# TLE985x-Errata-100-Infineon

## TLE985xQX(W) Family

This document lists the errata of the TLE985xQX(W) family.

**Figure 1** Clock generation unit block diagram

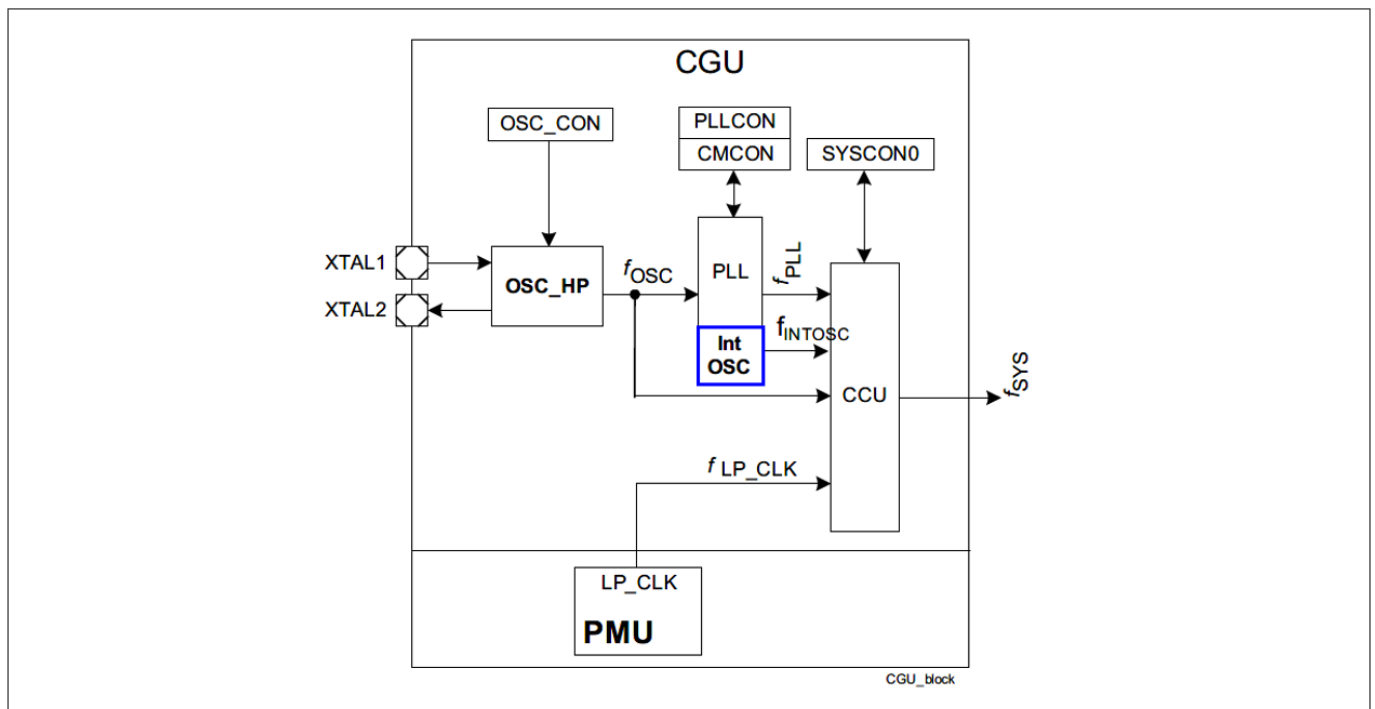
The TLE985x provides a Phase-Locked-Loop (PLL) to generate the system frequency. Under certain conditions it may happen that the PLL issues a loss of lock. The probability for an erroneous PLL loss of lock to occur increases with higher temperature and longer operation times.

In case of a PLL loss of lock, the system frequency will be switched to free running clock divided by K2, this might have the following effects to the application:

- System timing do not match anymore, e.g. LIN communication might not work properly, PWM period might be affected.
- WDT1 reset may occur.
- Digital filter times might not match anymore.

**Figure 2** SCU\_SYSCON0

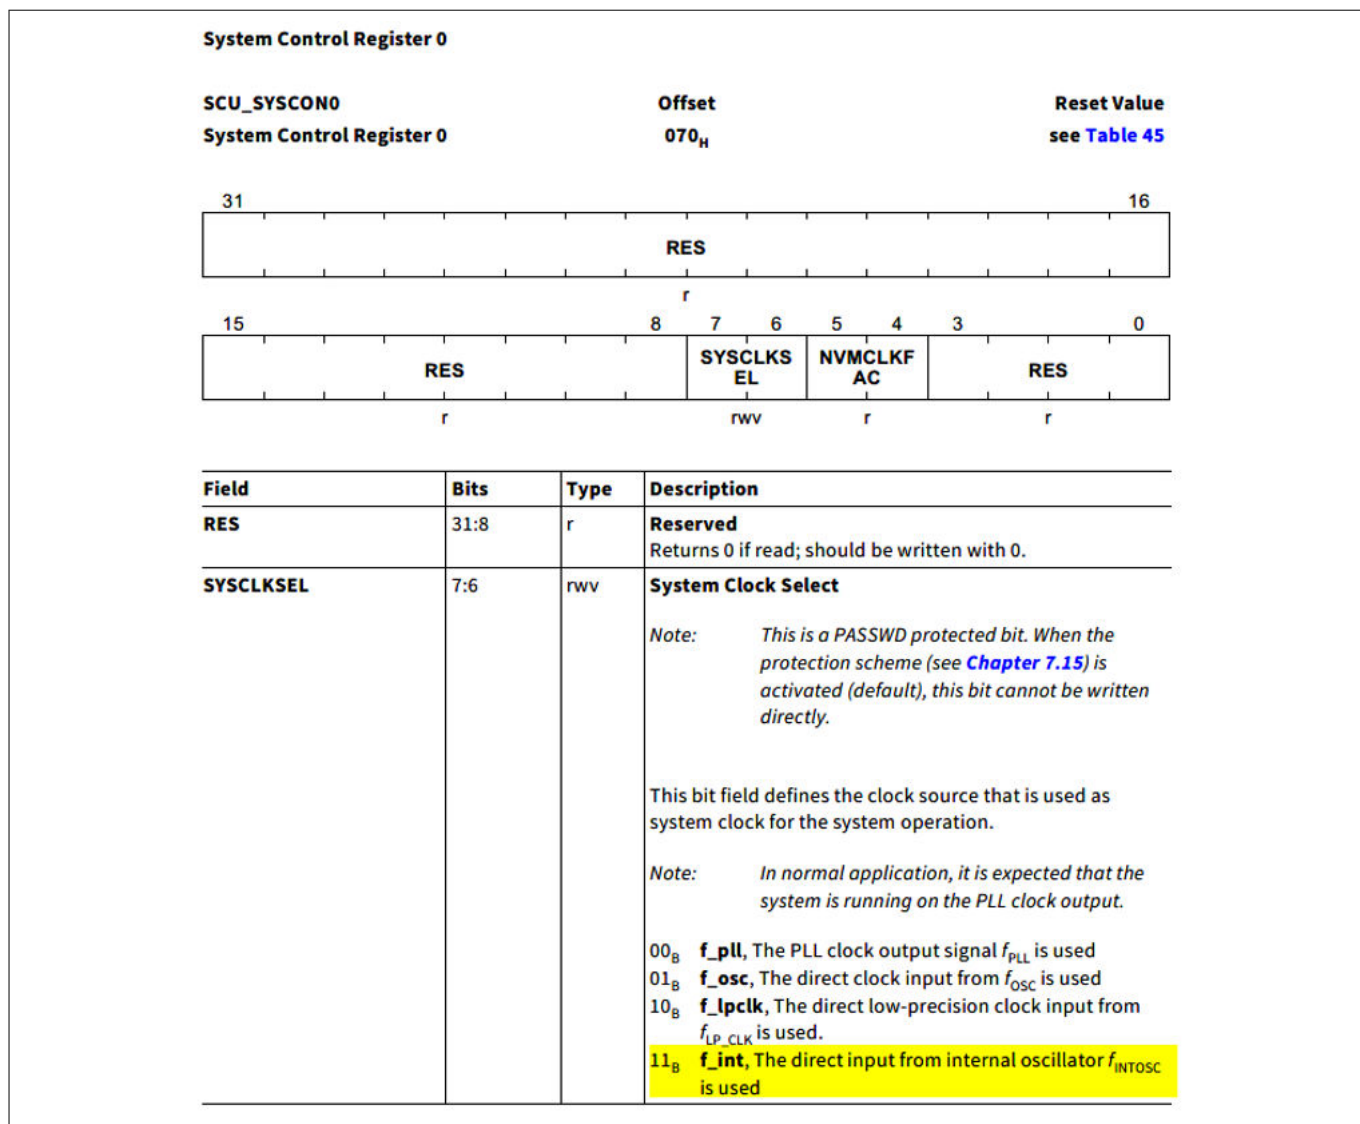
The switch to the internal oscillator will be done in the **System Control Register 0** by writing the bit field **SYSCLKSEL** to 11<sub>B</sub>:

Due to the fact that this register is protected, it is required to open the register password protection. Please use the following example as reference:

```
001    SCU_OpenPASSWD();
002    SCU->SYSCON0.reg = (uint32)0xC0;
003    SCU_ClosePASSWD();
```

**Figure 3** Application diagram example with C-R-C filters at MONx

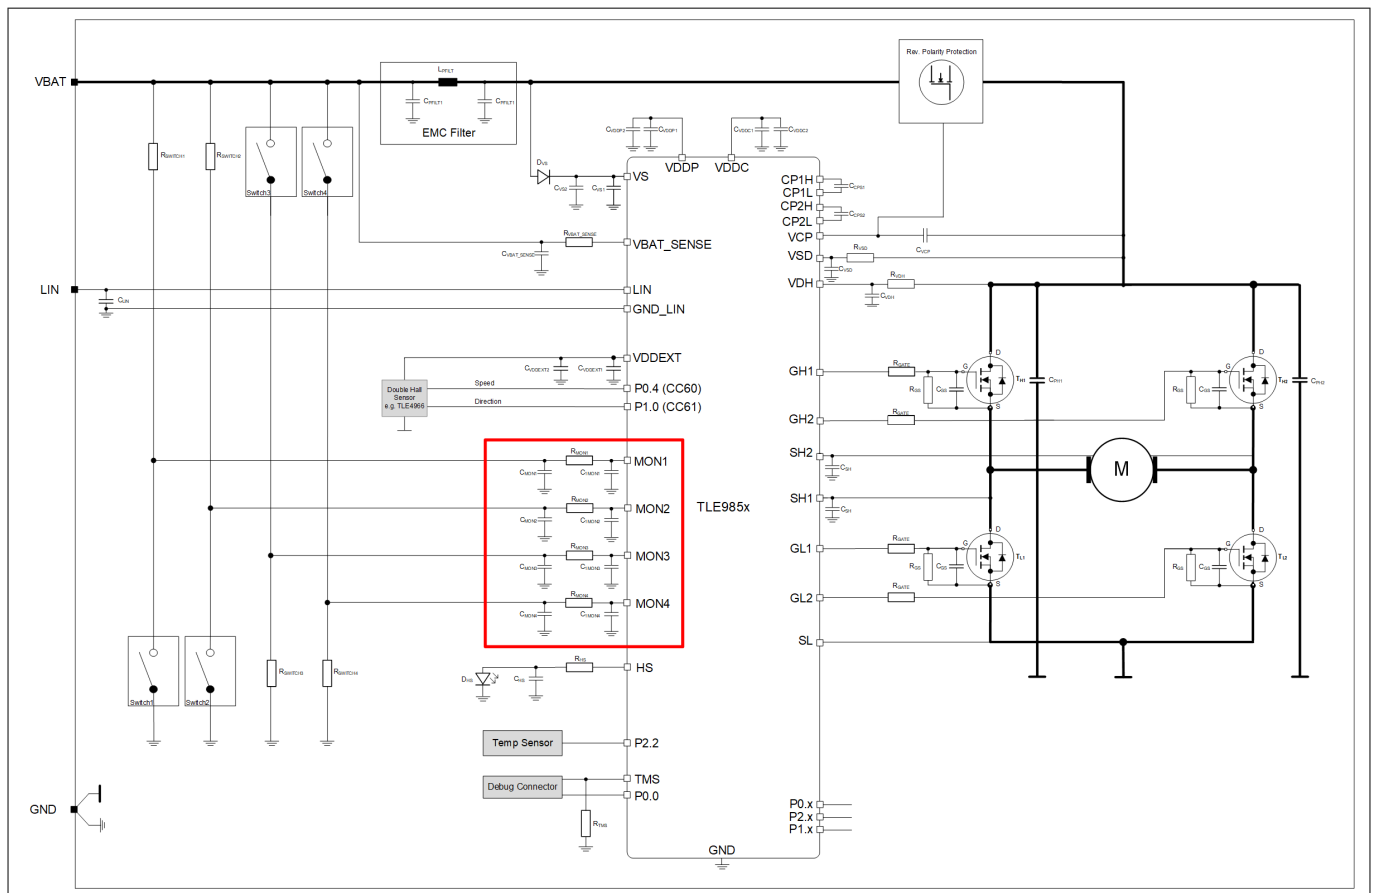
Fast transients on an enabled ADC1 HV-Channel could activate the ADC sampling switch, which will lead to a load of 10 k $\Omega$  (+/- 20%) on the causing channel.

The activation will increase the input current (> 100  $\mu$ A @  $V_S$  13.5 V) on the corresponding MONx pin. This increased current can cause a voltage drop across the external resistor. Depending on the value of the resistor, the voltage drop can be so high that a wrong low signal on the MONx will be detected.

To achieve robustness against ISO 7637-3 pulses, the recommended R-C filter from the Data Sheet is sufficient. To increase the robustness, an additional 10 nF capacitor ( $C_{1MONx}$ ) is recommended. This will lead to a C-R-C filter. See [Figure 3](#).
